Work Order ID 112863

Item Name: Aft Crosstube

DRAWING NO. D407-667-245	TITLE CROSSTUBE ASSY (407 HIGH AFT)	REV. F	DART AEROSPACE LTD ENGINEERING ORDER		D.E.O. NO. D407-667-245-F-1	SHEET NO. SHEET 1 OF 2	SCALE NTS
DRAWN	CHECKED	MFG. APPR.	APPROVED	DE APPR.			
DATE 11.04.08	DATE 11.04.12	DATE 11.04.12	DATE 11.04.12	DATE 11.04.12	DATE 11.04.12

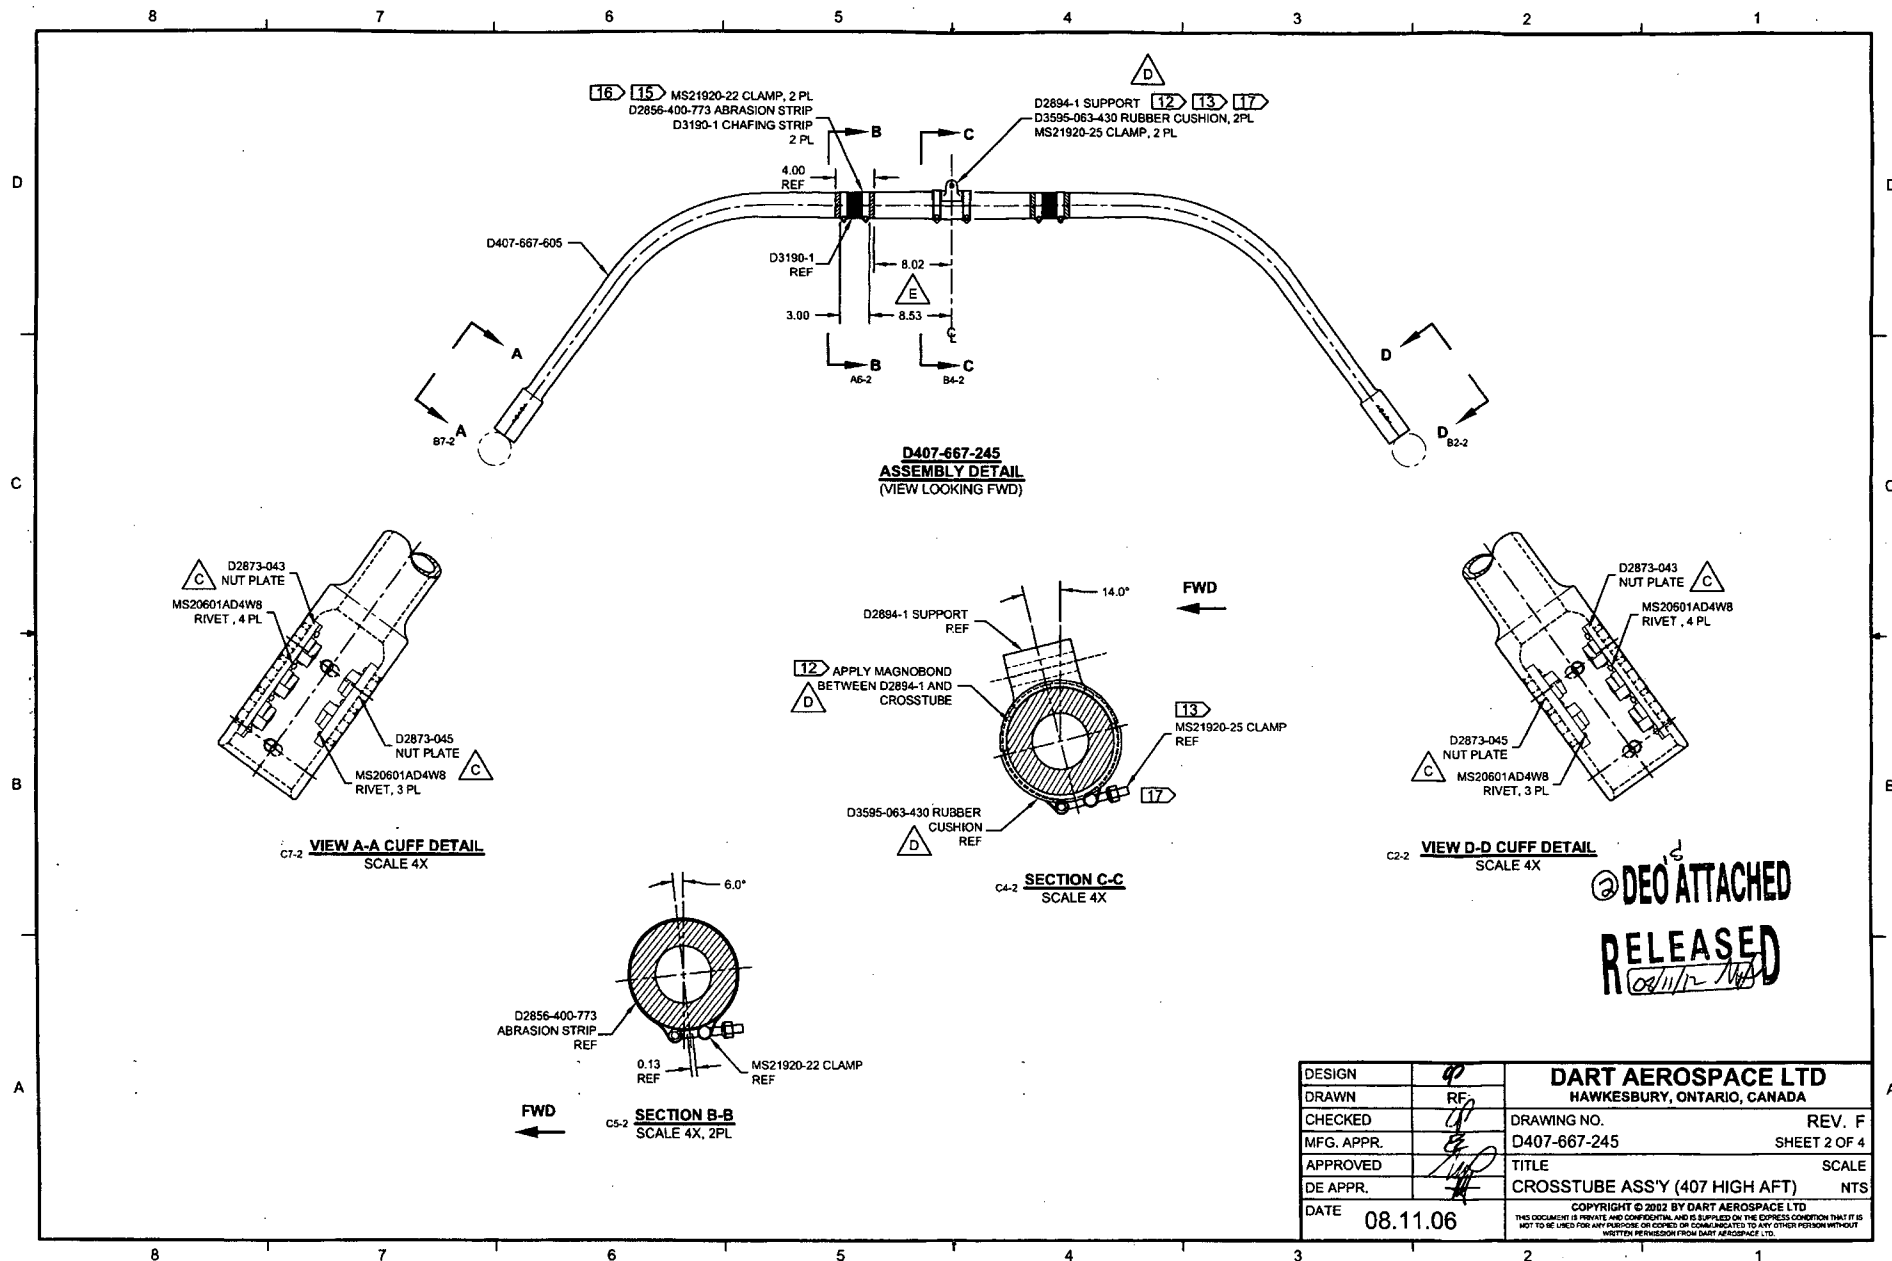
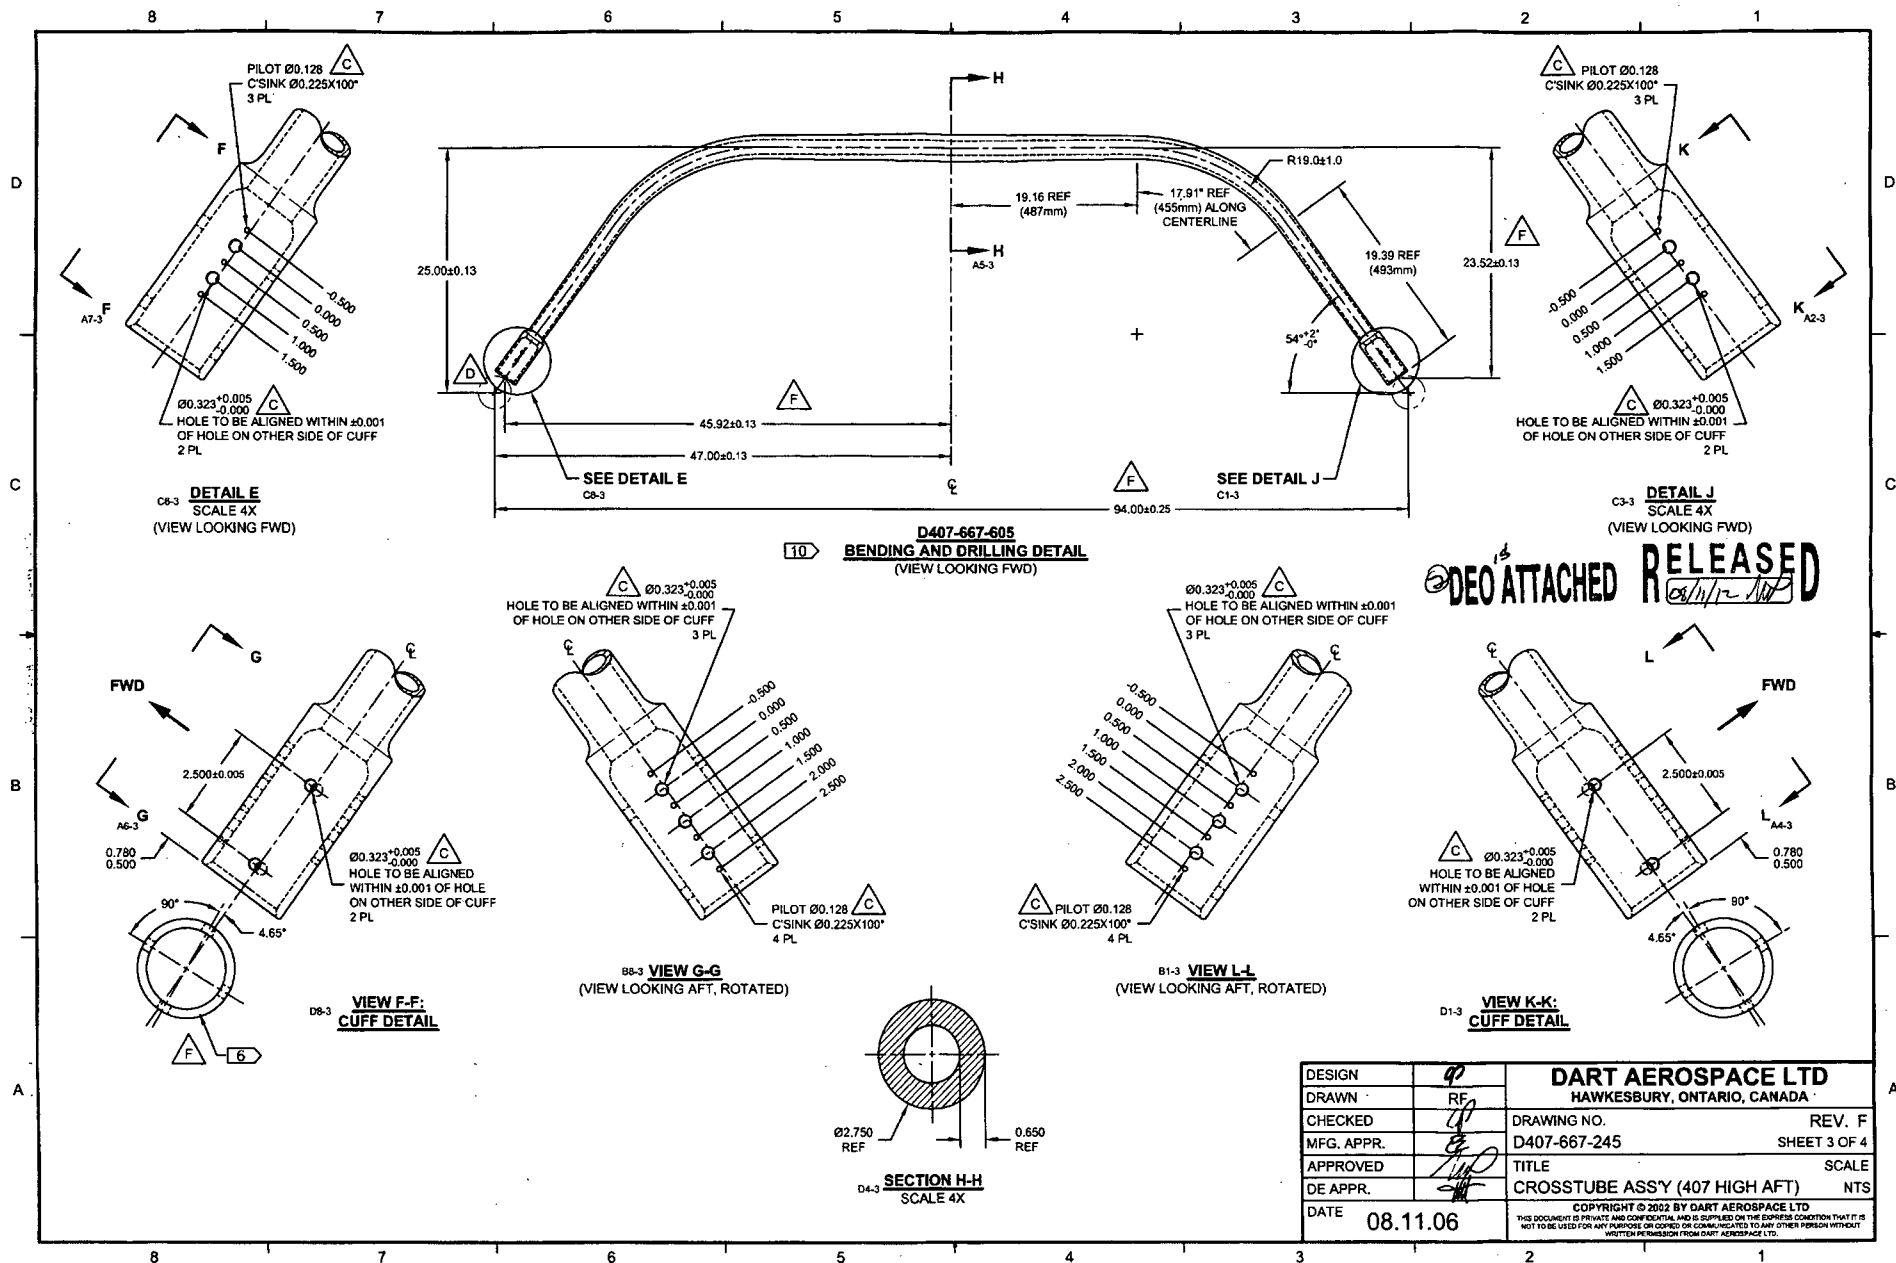
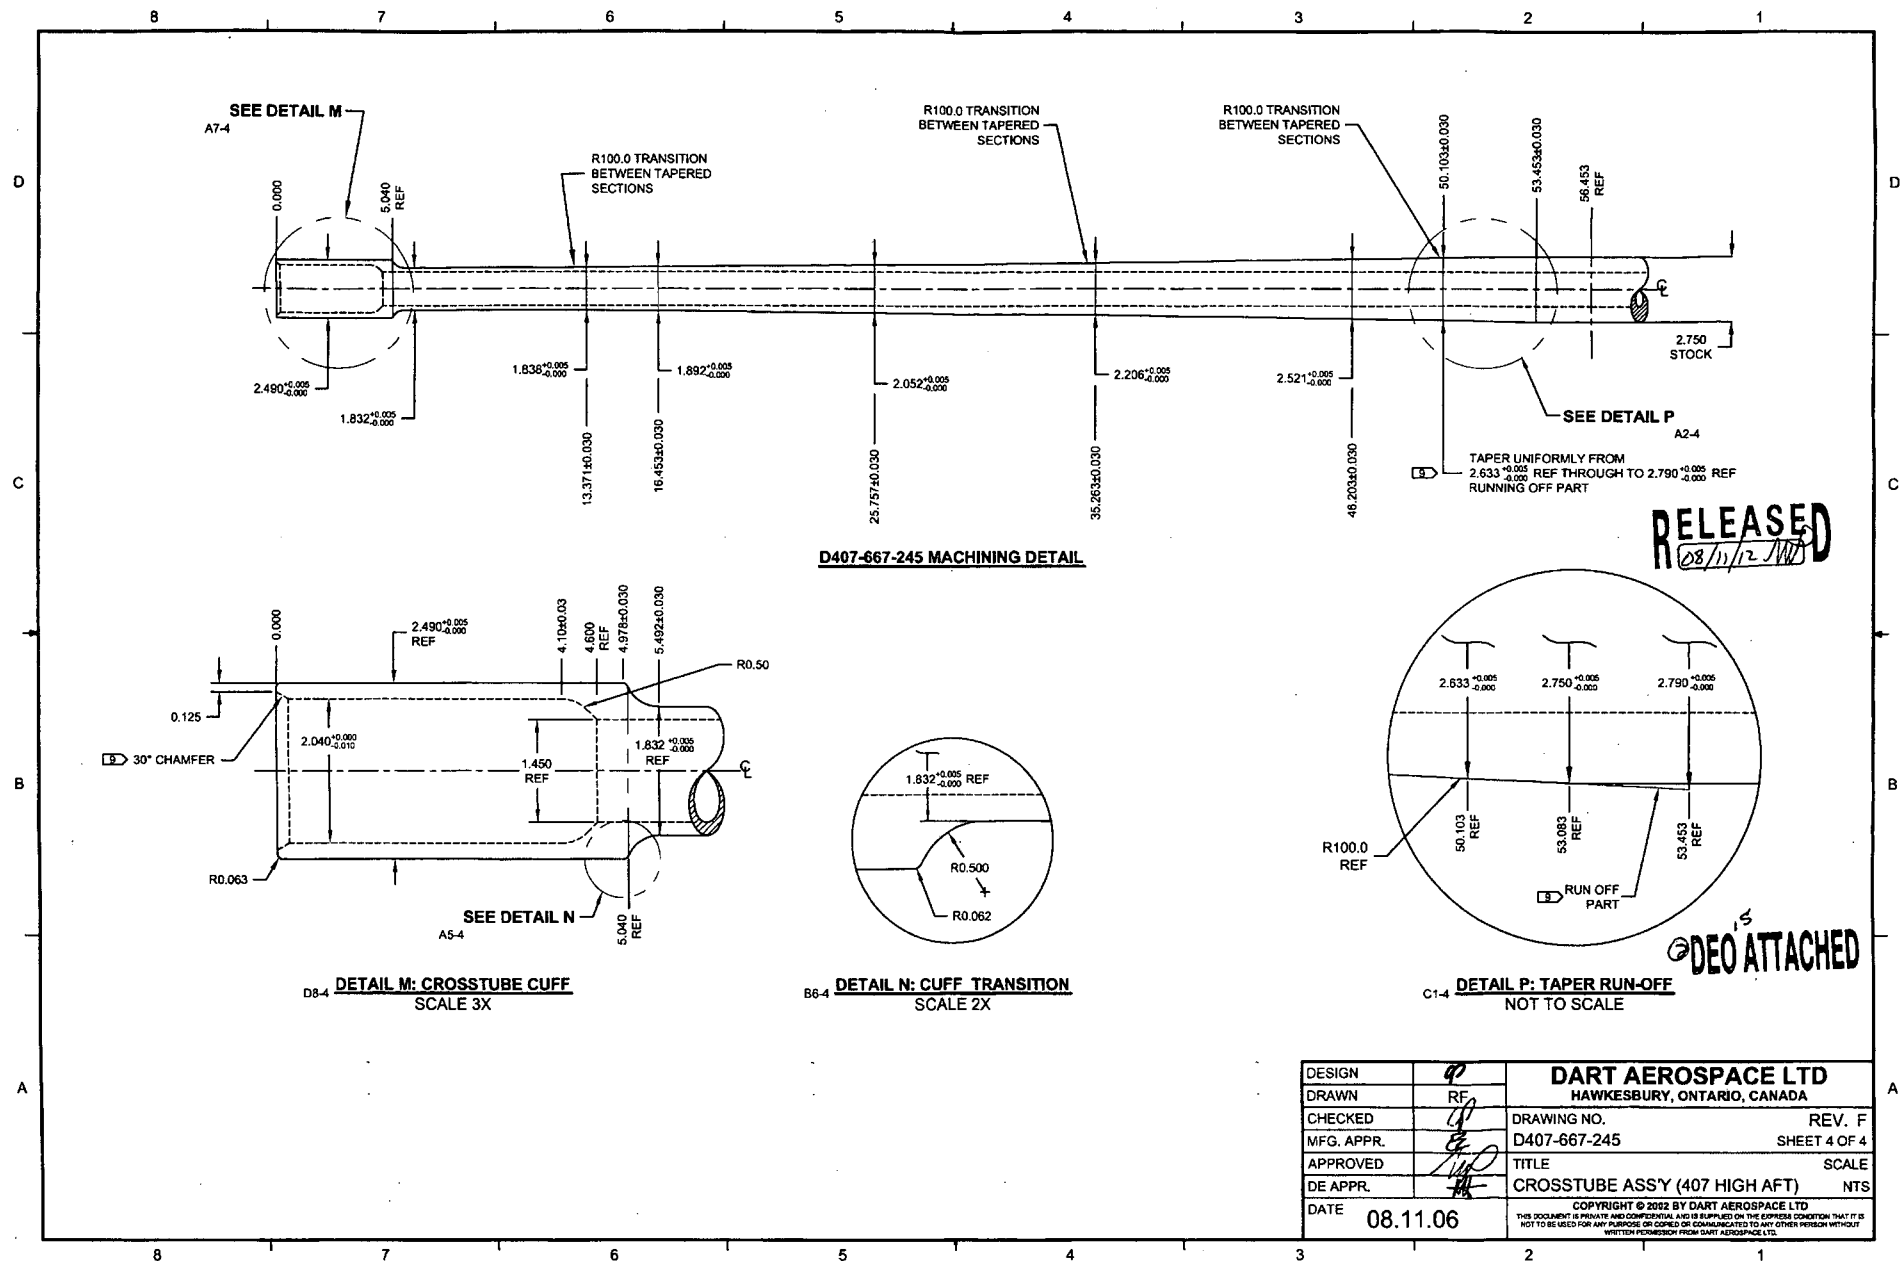
F	REFORMAT NOTES TO NEW STANDARDS (ZN B8-1); RELOCATED FLAG # 6 (ZN A8-3) PER NCR 210; REMOVED REF. & ADD TOLERANCES (ZN C6-3, C4-3 & D2-3)	RF	08.11.06
E	8.02 AND 8.53 WERE 8.40 AND 8.90 (ZN D5-2); REORGANIZED VIEWS AND REFORMATED DRAWING TO CURRENT STANDARDS. REASONS: CLAMPS MOVED 0.375 TOWARD CL TO ELIMINATE INTERFERENCE WITH AIRCRAFT MOUNTS. REFERENCE: FAR#08-21 AND ECR#1225	MB	08.07.24
D	ADD VIEW FOR OEM SKID HOLES, ROTATE ORIENTATION OF CLAMPS SECTION F-F, REMOVE -851 ABRASION STRIP, ADD MAGNOBOND 6398, ADD CUSHION	PH	07.02.07
C	ADD HOLES AND NUT PLATES FOR COMPATIBILITY WITH BHT/AA SKIDTUBES	PH	05.07.26
B	ADD CHAFING SHIELD	CP	03.05.21
A	NEW ISSUE	CP	02.05.13
REV.	DESCRIPTION	BY	DATE
DESIGN	90		
DRAWN	RF		
CHECKED	CP		
MFG. APPR.	CP		
APPROVED	CP		
DE APPR.	CP		
DATE	08.11.06

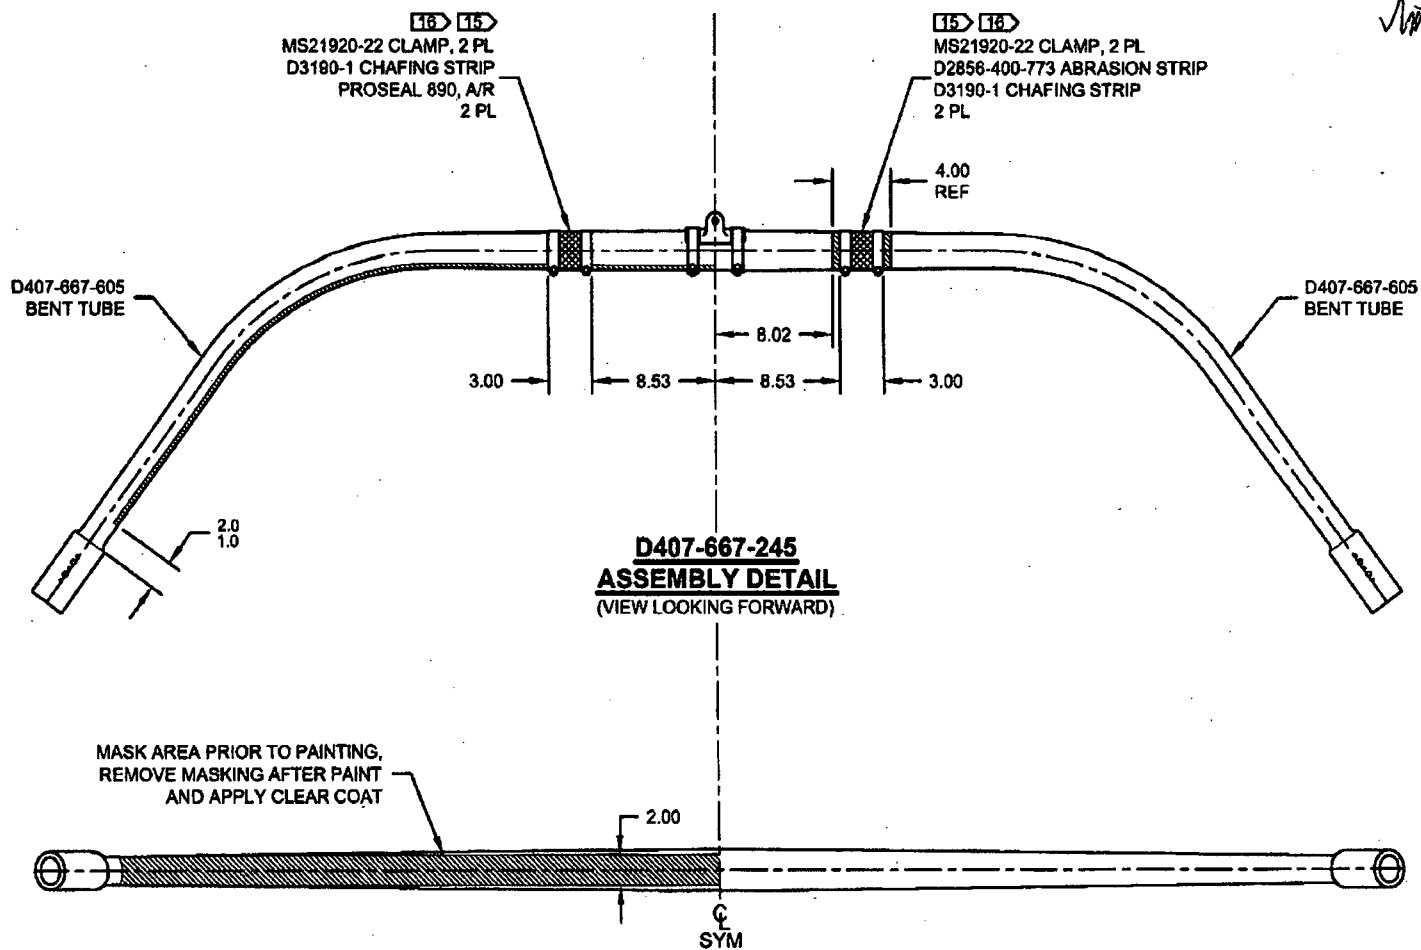
NOTES 2 AND 15, SHEET 1 ARE AMENDED AS FOLLOWS:

- 2) FINISH: CHEMICAL CONVERSION COAT PER DART QSI 005 4.1
PRIME INSIDE AND OUTSIDE PER DART QSI 005 4.2
MASK UNDERSIDE OF CROSSTUBE AS SHOWN (HATCHED AREA) AND
PAINT OUTSIDE PER DART QSI 005 4.2
REMOVE MASKING AND APPLY CLEAR COAT
- 15) APPLY A THIN COAT OF PROSEAL 890 ON INSIDE CONCAVE SURFACE OF D3190-1
CHAFING SHIELDS AND LET CURE PER MANUFACTURER'S INSTRUCTIONS. INSTALL
PROSEAL D3190-1 CHAFING SHIELDS ONTO CROSSTUBE BY APPLYING A THIN COAT
OF PROSEAL 890 ONTO CROSSTUBE. BE SURE TO ELIMINATE ANY AIR GAPS.

IS:
